RE: CDO and WDR for NPDES
permit and related documents
Santa Susana Field Laboratory
CA0001309 CI NO. 6027
CDO R4-2009-00XX

Cease and Desist Order No. R4-2009-00XX

Revised Tentative Board Order – Waste Discharge Requirements (WDR) R4-2009-00XX:

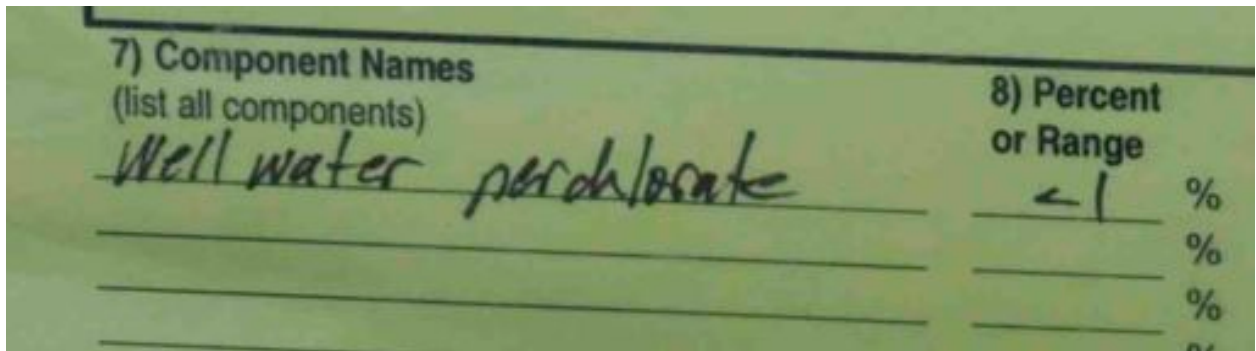
TCE contamination is incorrectly estimated in these documents, which underplays the potential impact to surface water run-off through contributing seeps and springs. The figure 530,000 gallons of TCE is incorrect as it is based on a number of either 30,000 rocket tests or as described in the TechLaw report:

According to "The First 25 Years," 150,000 rocket engine tests had been completed at SSFL by 1962 (RCK 32534), and 200,000 such tests by 1964 (RCK 32538). The timetable prepared by Rocketdyne's Environmental Division also indicates that SSFL had done 150,000 rocket tests by 1962 (see Figure 7; RCK 04268). Nevertheless, when preparing calculations of the amount of TCE discharged to the groundwater as a result of engine flushing, the Environmental Division based its estimates on a total of 8,000 engine tests (ACE 05756).

Since these figures are being used to model and calculate the needed pumping and other treatments that would effectively remove the contaminant, it is necessary to be sure that accurately reflected usage is recorded here. With estimates that are underplayed by 100-fold as it appears to be here, we have no shot at actually remediating the problem. We must first acknowledge the problem accurately so that appropriate methods of remediation can be considered.³

Stored water is marked “Outfall 18” which leads us to question the perchlorate detections that have occurred and the believed source for those detections

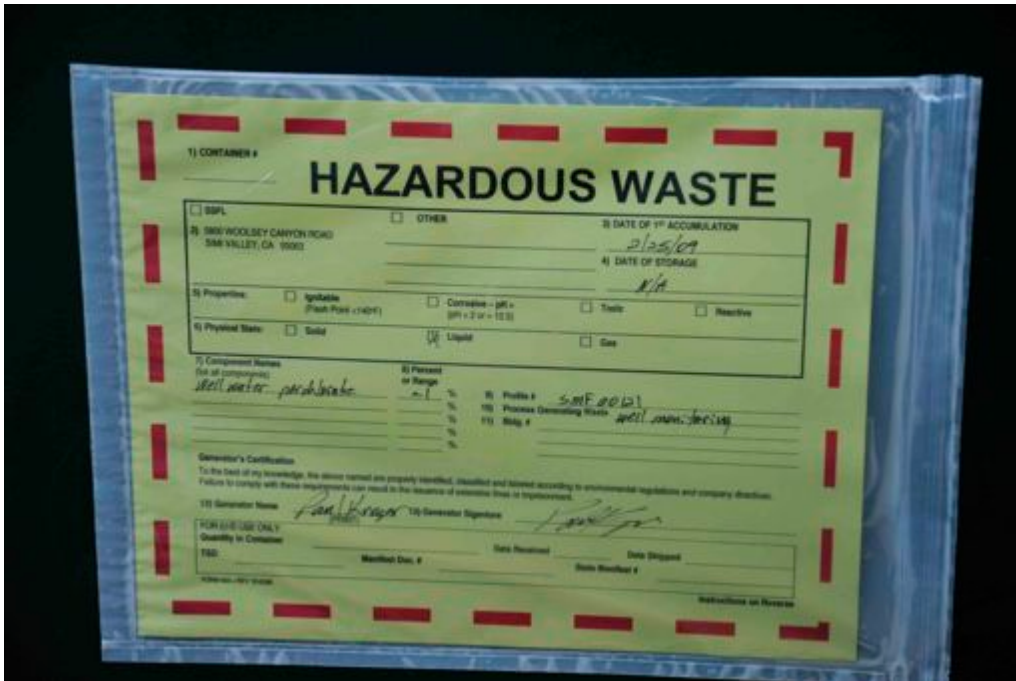
Recent high concentrations detected near WS9a where pumping activities to “dry out the seep” have taken place, are indicative of preferred pathway that may not be readily apparent. Severe contamination is visible at the R2 Pond which has recently been drained during the ongoing water reclamation management program where stored water is containerized at various locations at the site including one that is adjacent to the R2 Pond where the pumping has occurred. In addition, both “trace solvent” water and “purge water” containing both Perchlorate and TCE were observed that are believed to originate at outfall 18. Perchlorate and TCE levels on this side of the site are not well understood.
